ADDENDUM TO THE CONTRACT

PICTURE POINT WAYSIDE

ADDENDUM NO.: TWO

SHEET TITLE:
TYPICAL SECTIONS

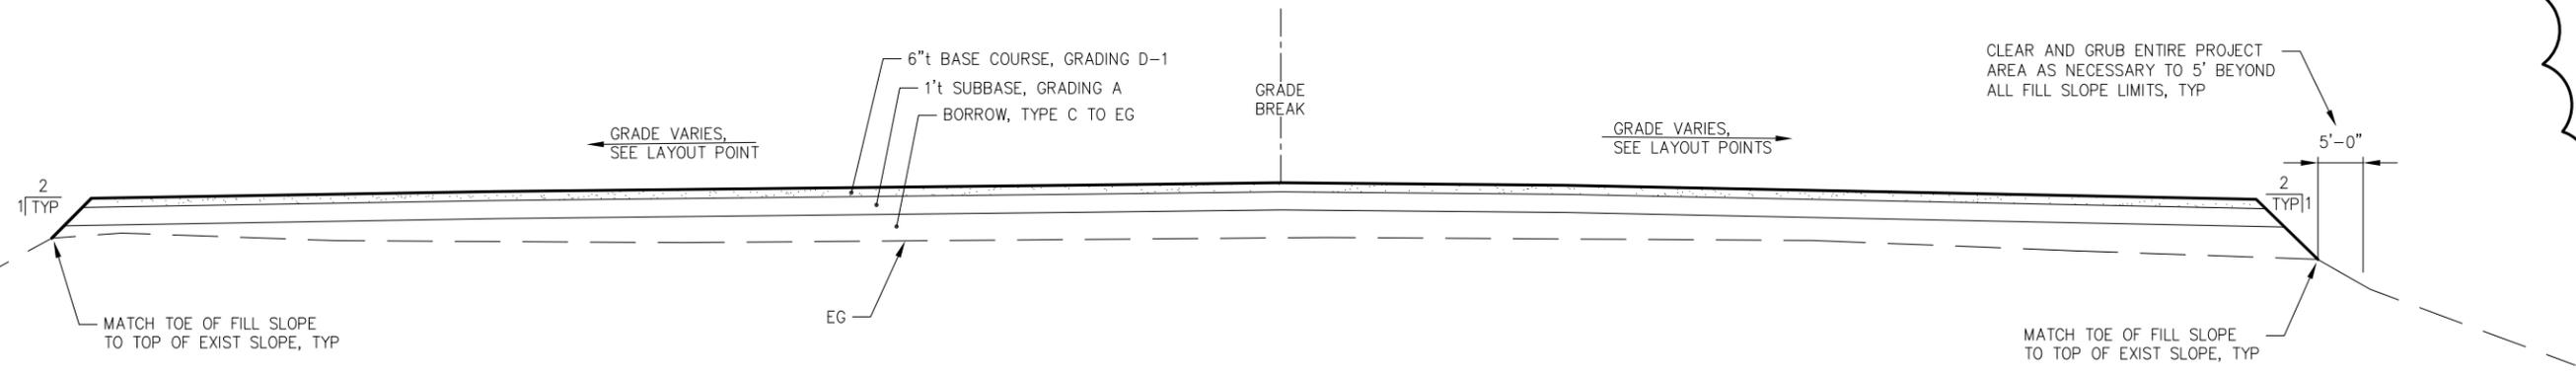
Item No. 1 DRAWING SHEET 5, 5 of 5, TYPICAL SECTIONS:

Replace the entire sheet with the attached drawing.

REVISIONS					
REV.	DATE	DESCRIPTION	DWN.	CKD.	APP.
△	11/12/14	ADDENDUM # 2	SCS	CRS	CRS
